# Technical Service Information

## FORD/MAZDA CD4E/LA4A-EL CONTINUOUS FRONT SEAL LEAK OR SEAL BLOW-OUT

Figure 1

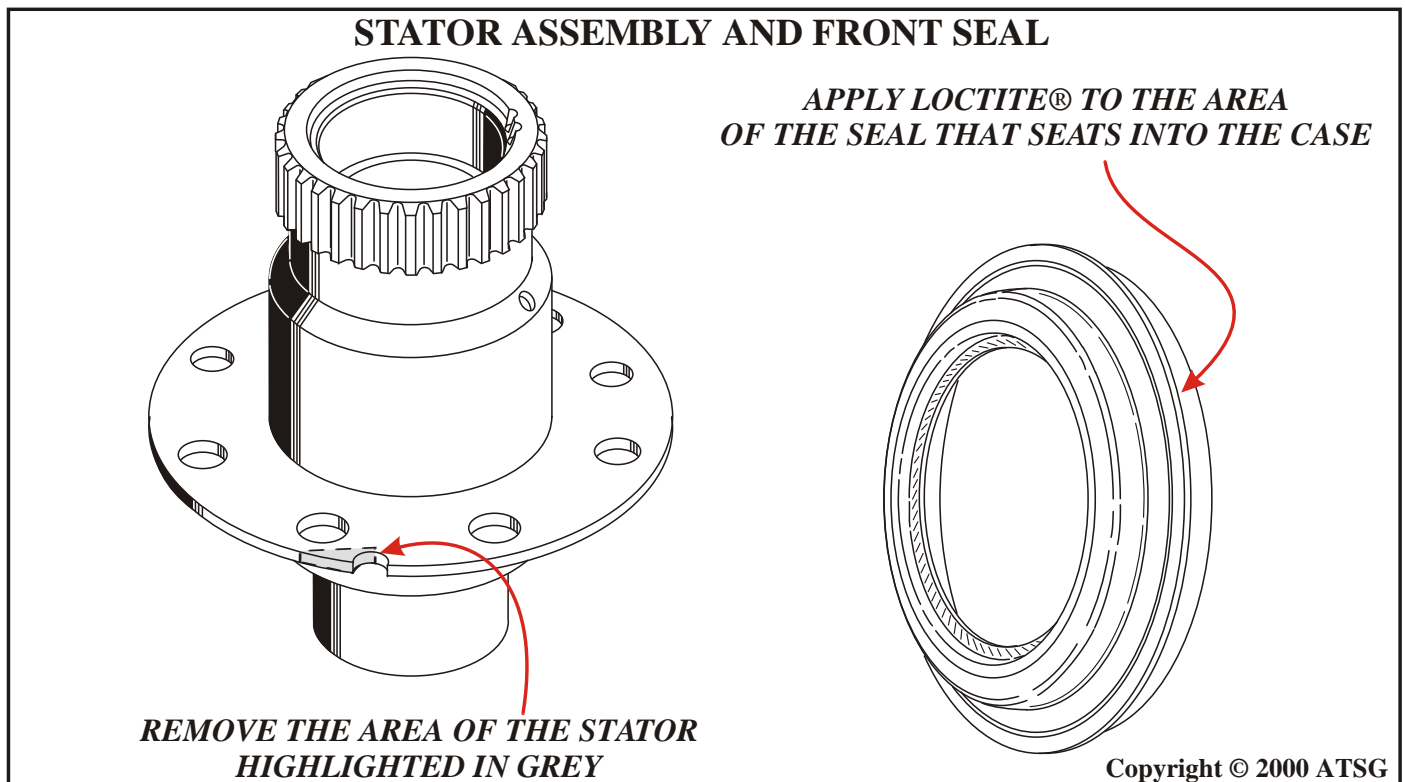
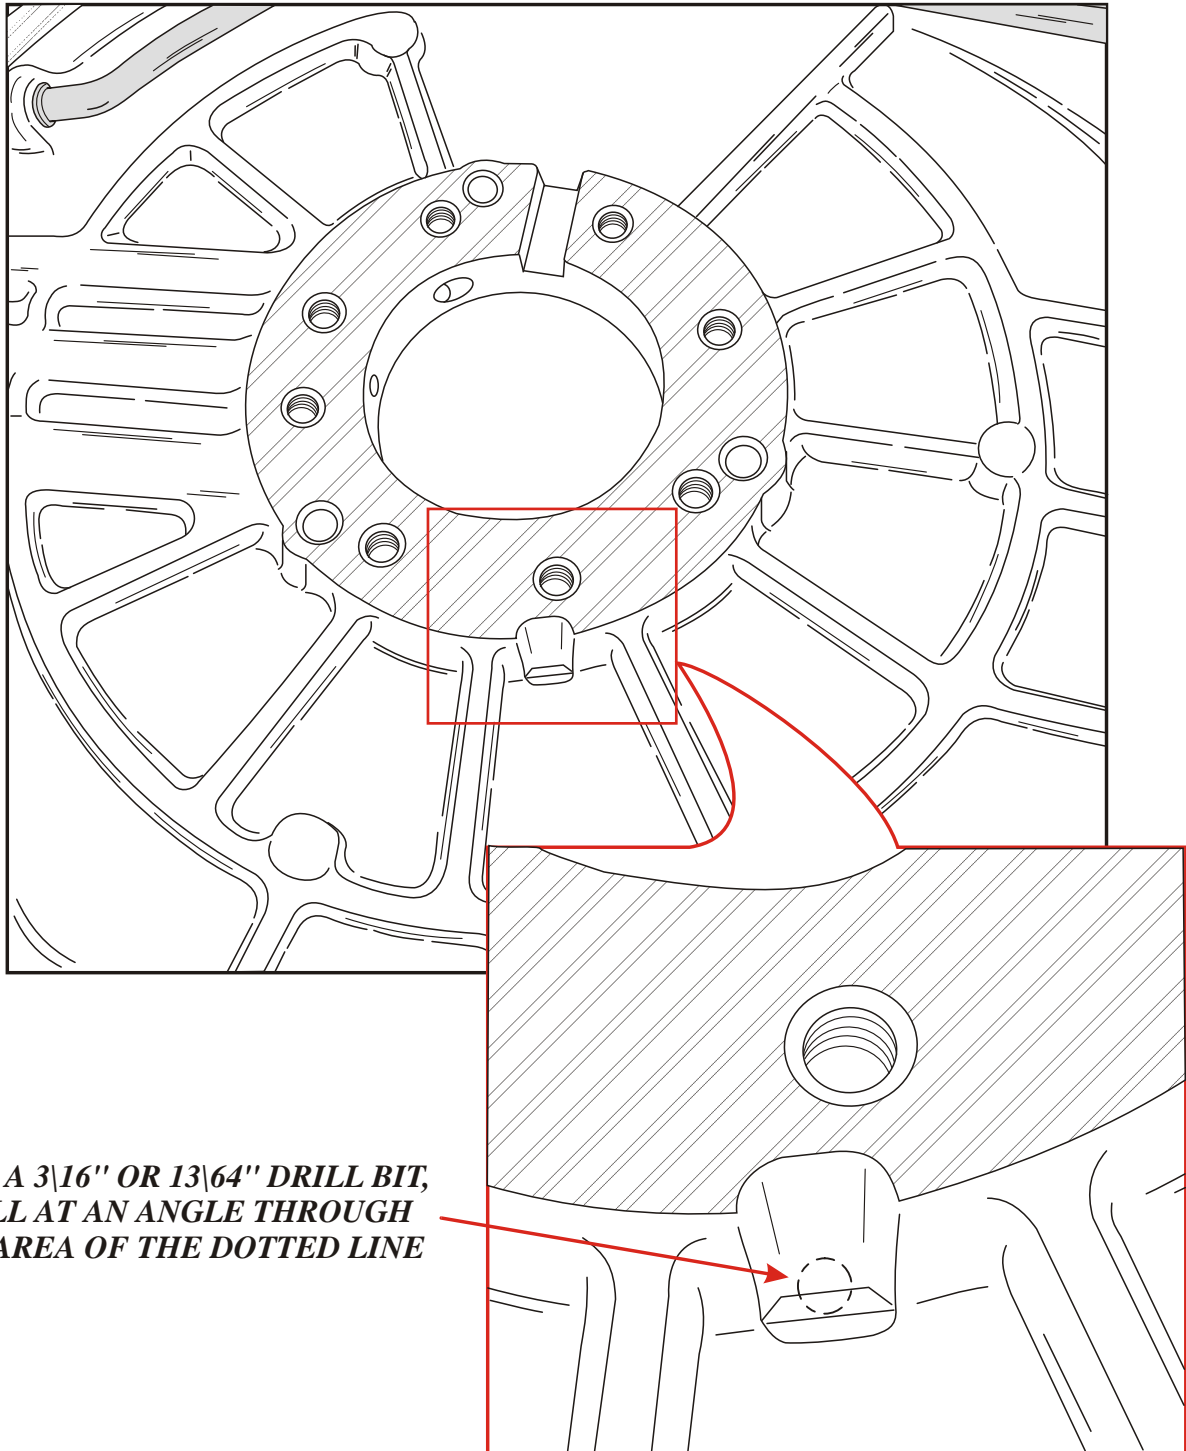
1. Remove the stator from the front of the bellhousing. Remove the area highlighted in gray, as shown in Figure 1, with a bench grinder.
- Note: Heating the bellhousing up in a parts washer will ease Stator removal.*
2. With a 3/16" or 13/64" drill bit, drill at an angle through the area shown in Figure 2.
3. Refer to Figure 3 to see the modified drain back passage from the front side of the bellhousing.
4. Apply Loctite ® to the front seal outer diameter before installing it in bellhousing, as shown in Figure 1.
5. Remove the transaxle if necessary, and ensure that the proper torque converter has been installed for the vehicle. Refer to Figure 4 for proper converter identification.

Figure 2

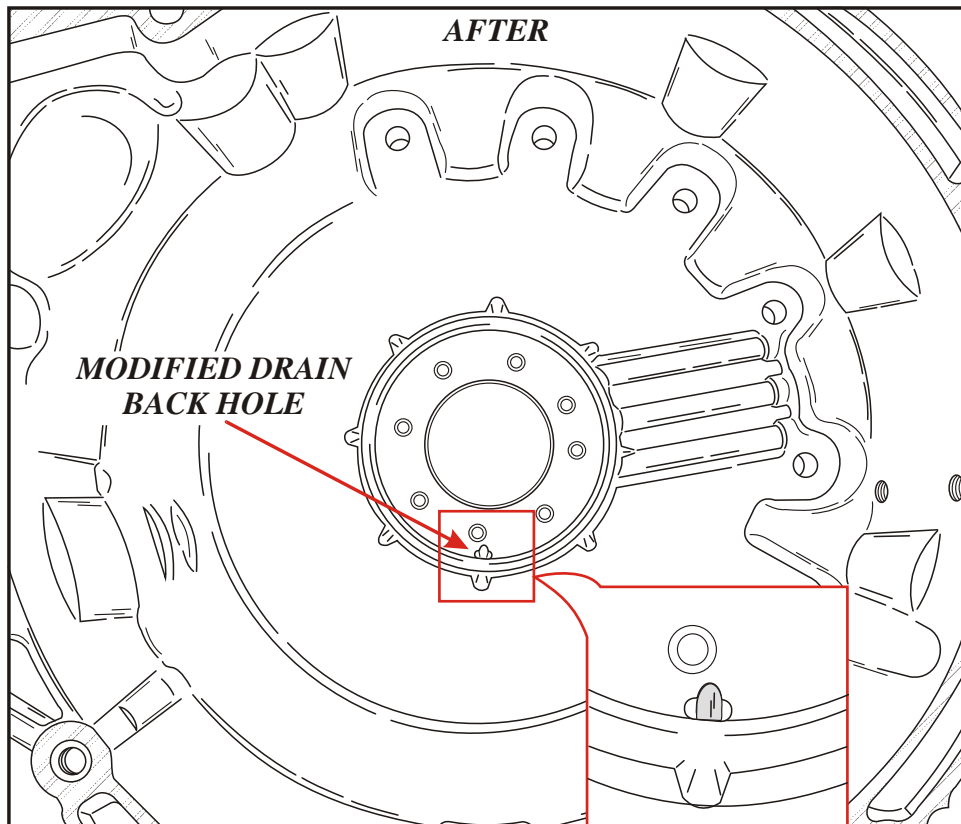
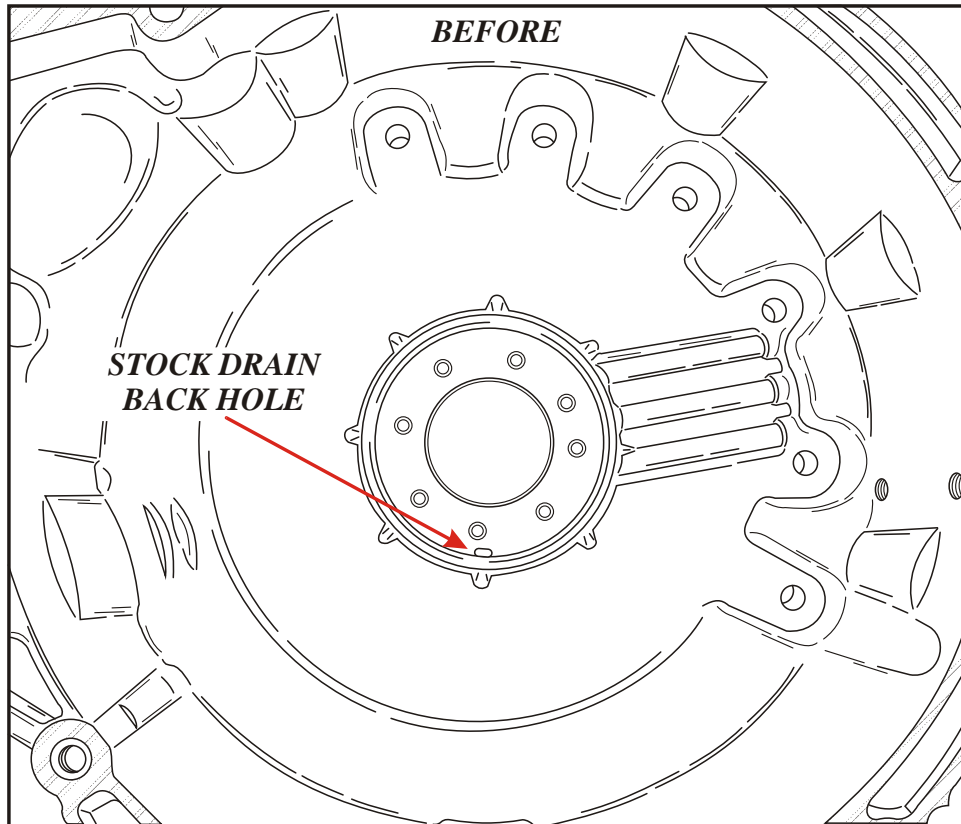
***WITH A 3/16" OR 13/64" DRILL BIT,  
DRILL AT AN ANGLE THROUGH  
THE AREA OF THE DOTTED LINE***

Figure 4

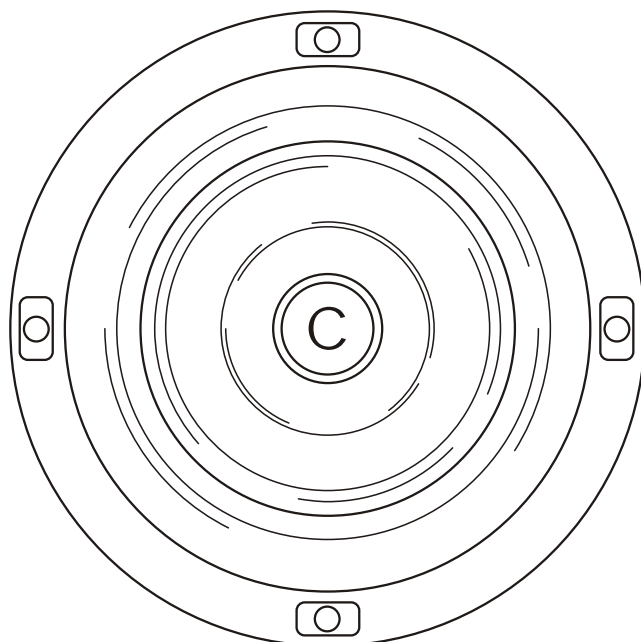
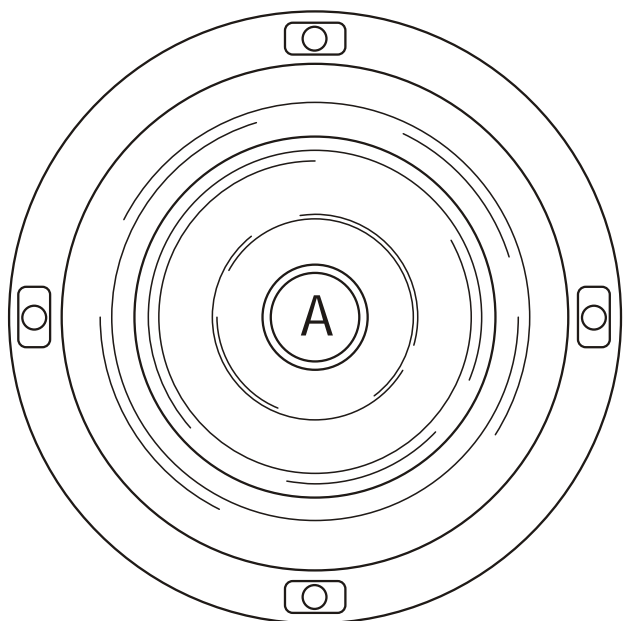
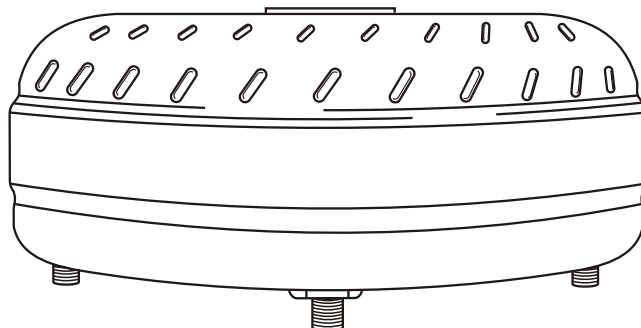
PART NUMBER	F-67	F-69
DIAMETER	10.50"	11"
HEIGHT	3.710"	4.125"
STAMP	"A"	"C"
MODEL	PROBE 626 MX6 CONTOUR MYSTIQUE	CONTOUR MYSTIQUE
ENGINE SIZE	2.0L	2.5L
